Re: St. Lucie Plant Unit 2
Docket No. 50-389
Renewed Facility Operating License No. NPF-16

Information Requested by NRC Reactor Systems Branch Regarding a Sample
Case Study for Boron Dilution Event in Support of the Extended Power Uprate
License Amendment Request

Response to Request for Additional Information

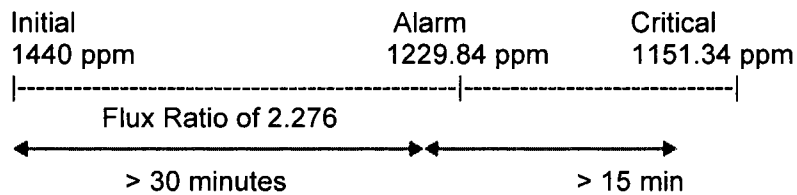
Provide a sample case that demonstrates how the boron dilution analyses are performed.

The time to dilute from the start of the event (1440 ppm) to the time when the BDAS alarm is reached (1229.84 ppm) is calculated next. For this calculation, UFSAR Equation 15.4.6-6 could be used. Instead, the ABORT code uses a more conservative approach which is based on the average dilution rate from the start of the event to the time when criticality is reached. This average dilution rate is calculated as follows for the selected sample case.

$$\text{Average dilution rate} = (1440 - 1151.34)/56.08 = 5.1472 \text{ ppm/min}$$

The time to reach the BDAS alarm is calculated based on linear interpolation as follows:

$$\text{Time to reach the BDAS alarm} = (1440 - 1229.84)/5.1472 = 40.83 \text{ min} (> 30 \text{ min was reported in the LAR}).$$

The time for operator action becomes $56.08 - 40.83 = 15.25$ min, which matches exactly the acceptance criterion (> 15 min was reported in the LAR).
